TECHNICAL INFORMATION

74488

Subject ▶ Change of Connecting Rod and Ring 10

For Models ▶ HM1810

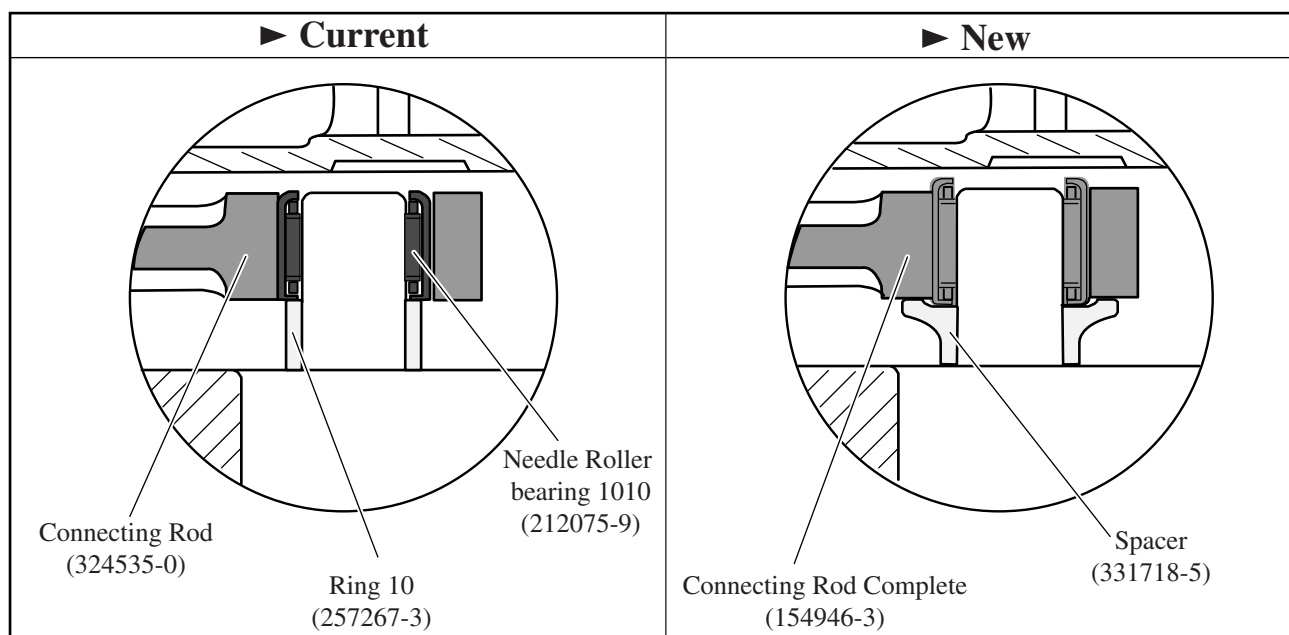
Description ▶ Connecting rod, Needle roller bearing 1010 and Ring 10 have been replaced by Connecting rod complete and Spacer as illustrated below.
The connecting rod complete consists of connecting rod and needle bearing 1012.
However, they can not be supplied respectively for repair.

Item No.	Current part		Q'ty	I/C	New part		Q'ty	Note
064	Connecting Rod 324535-0		1	No	Connecting Rod Complete 154946-3		1	Interchangeable as a set
063	Needle Roller Bearing 1010 212075-9		1					
071	Ring 10 257267-3		1	No	Spacer 331718-5		1

From serial No. 3448E (September 23, 2005)
